AGENDA
LANDMARK COMMISSION
REGULAR MEETING
4:00 p.m. Monday, April 3, 2023
City Council Chambers, 2nd Floor of City Hall
823 Rosenberg, Galveston, Texas

MINUTES OF THE LANDMARK COMMISSION OF THE CITY OF GALVESTON REGULAR MEETING – March 20, 2023

STAFF REPORT

Request for a Certificate of Appropriateness for modifications to the structure including enclosing the existing rear porch and adding a new rear porch.

14TH STREET - SITE PLAN

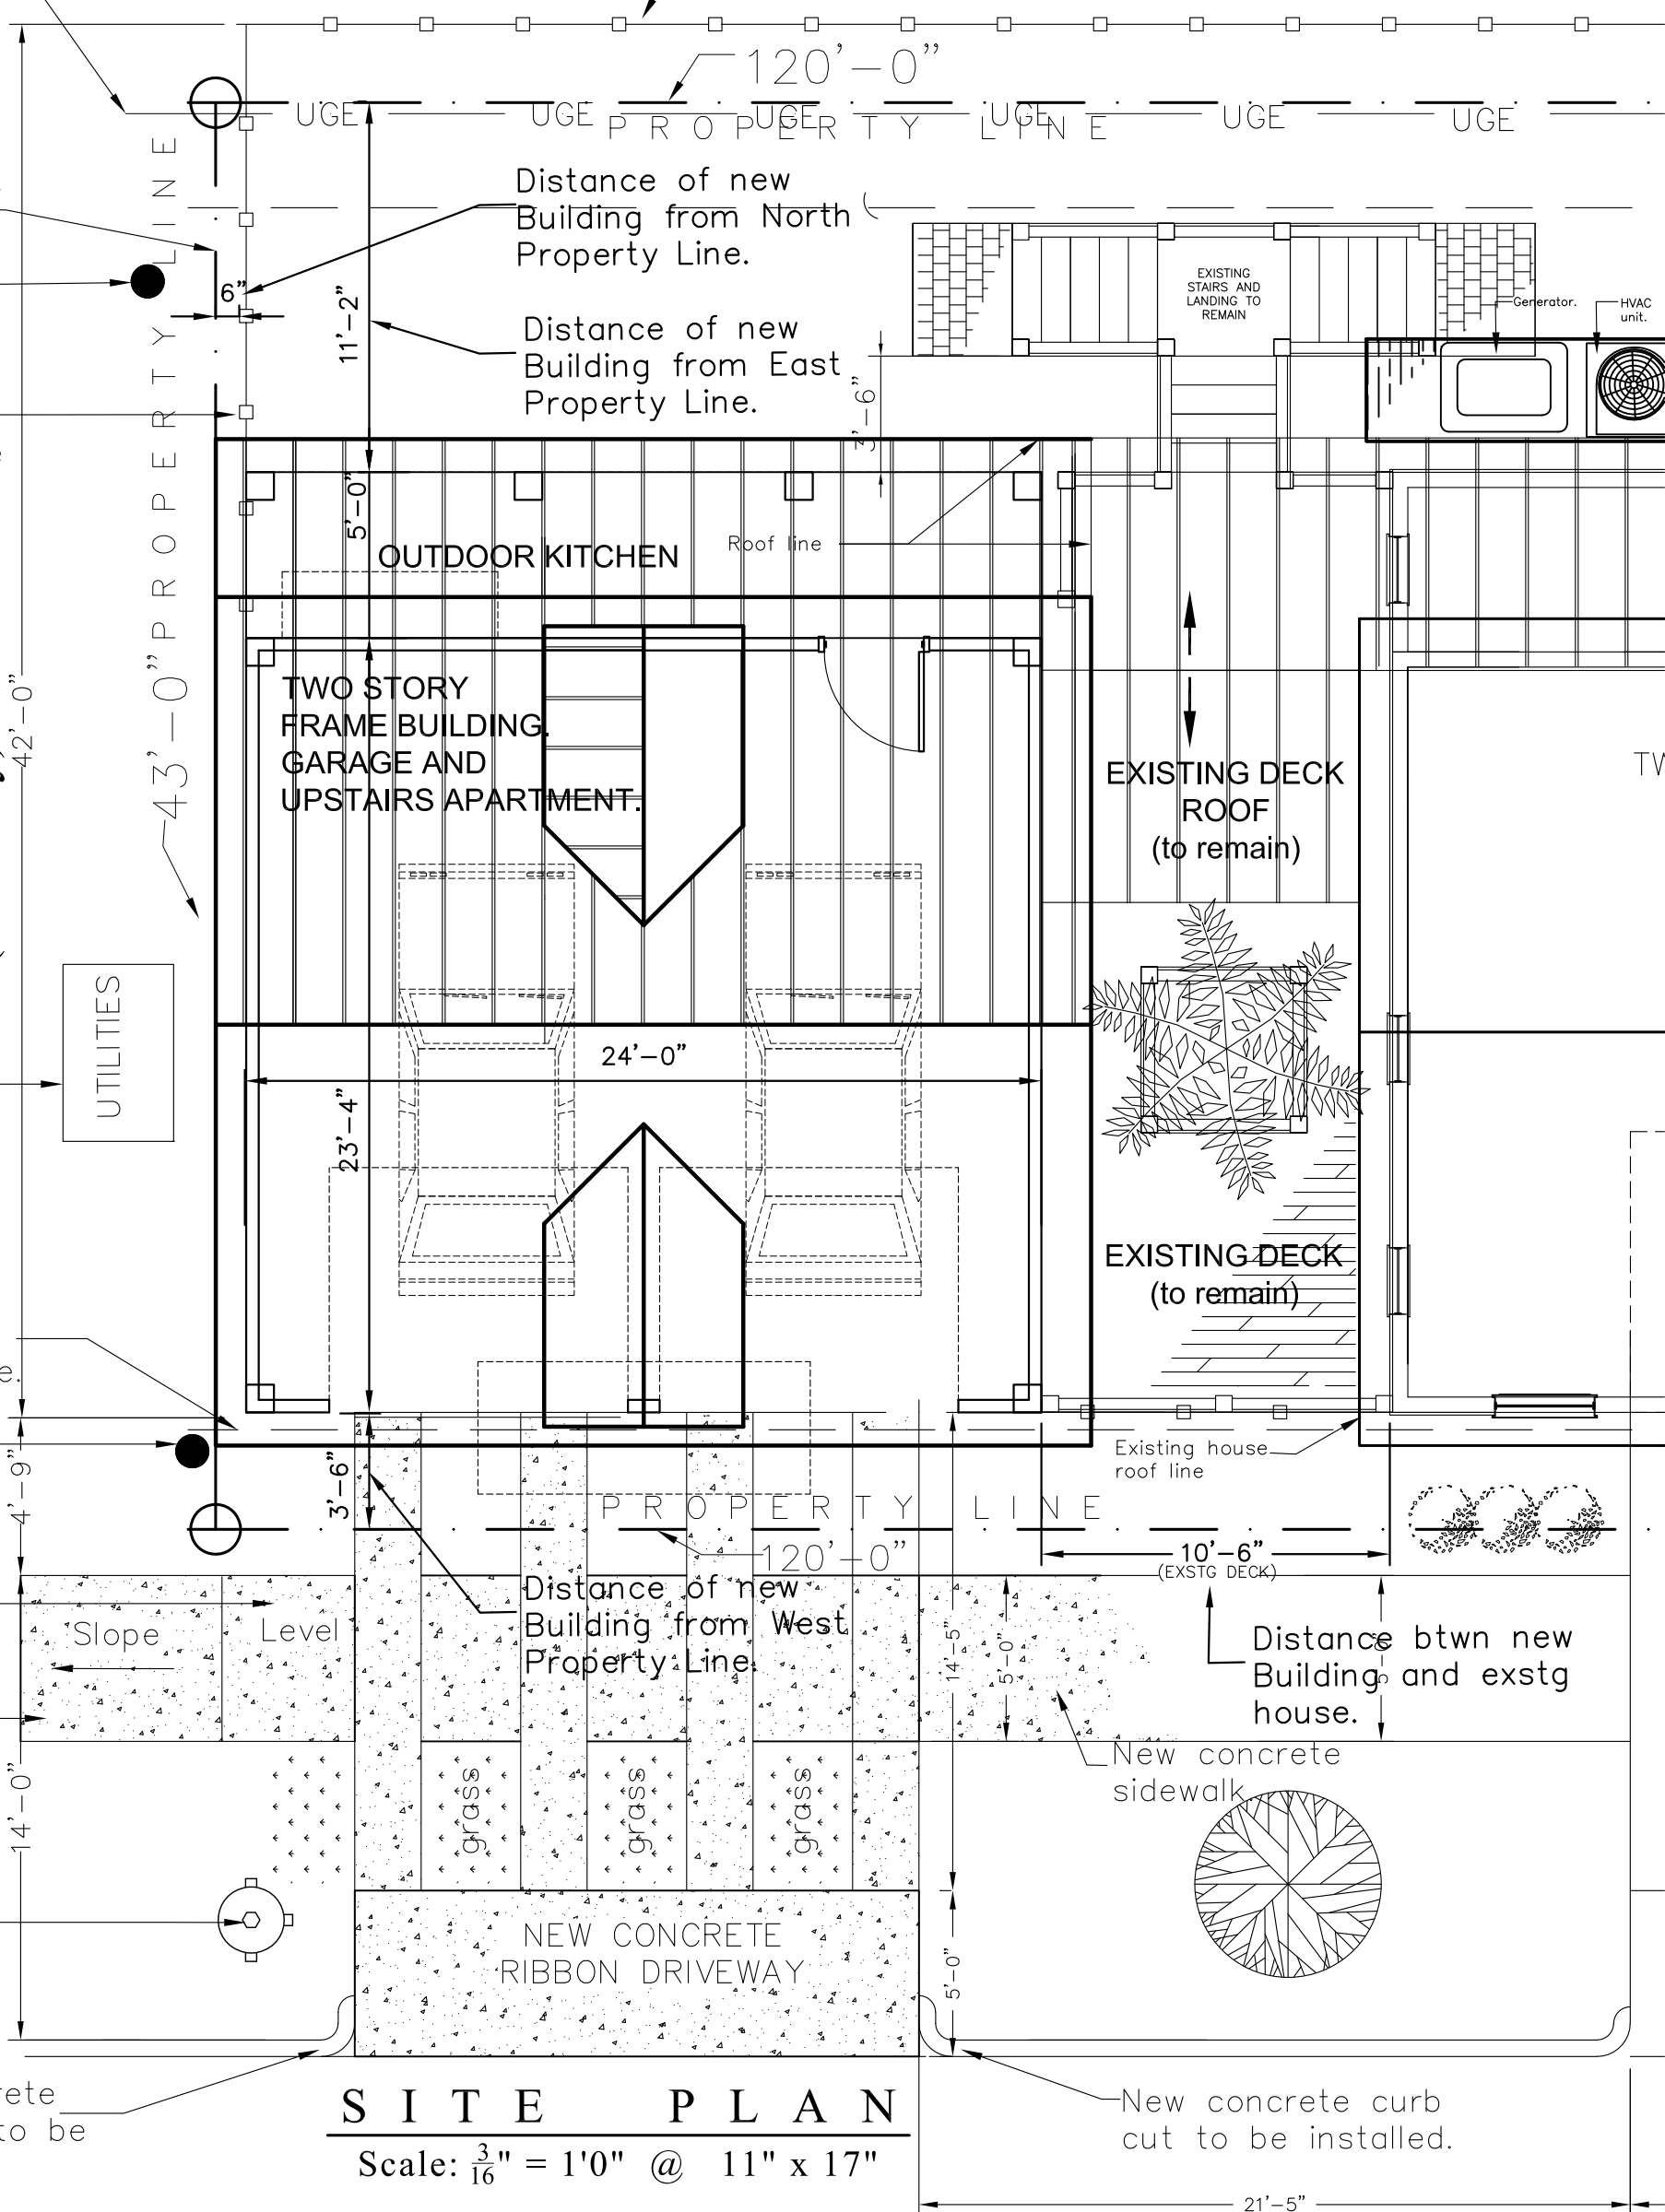
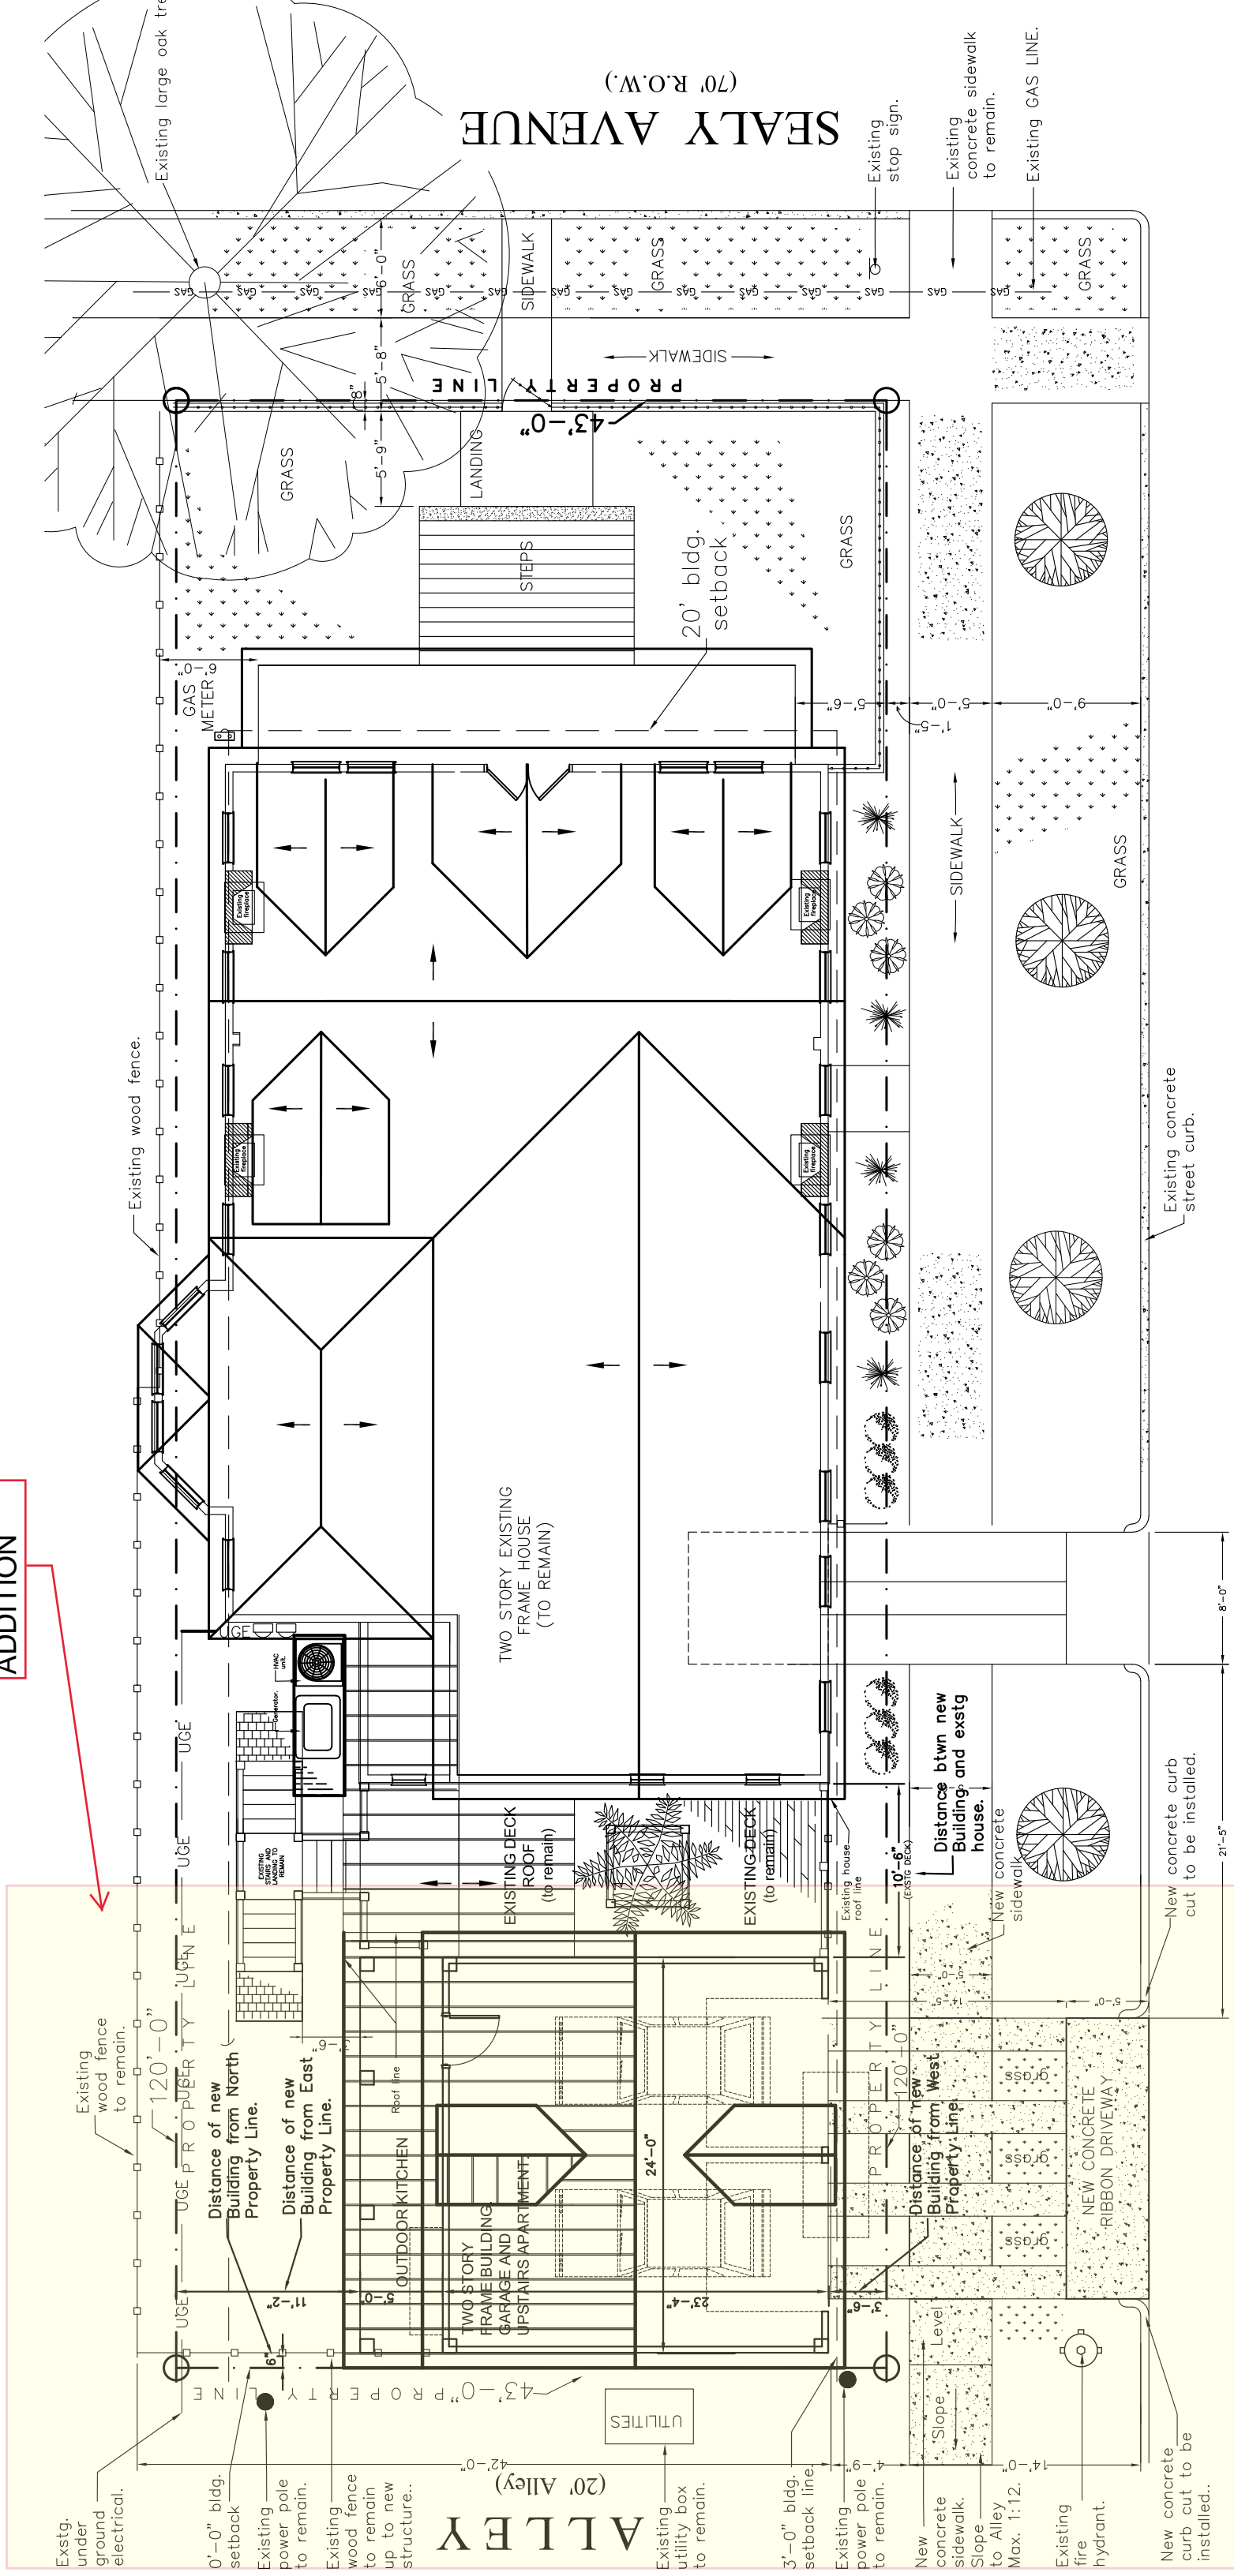
However, the request does not conform to the Design Standards regarding new driveways and garages, which are not allowed on a primary street. Staff recommends that the new driveway on 14th Street be omitted, and the garage doors be modified to access the alley directly behind. In addition, the proposed drawings depict windows with divided lights. While this is often appropriate for new windows added to historic homes, for new construction 1-over-1 windows are recommended by the Design Standards.

1. The exterior modifications shall conform to the design, materials and placement presented in Attachment A with the following modifications:
 - a. The proposed garage apartment shall be modified to provide automobile access (garage doors) from the alley only, and the proposed driveway onto 14th Street be likewise omitted;
 - b. Windows in the new addition shall be of a 1-over-1 light configuration;
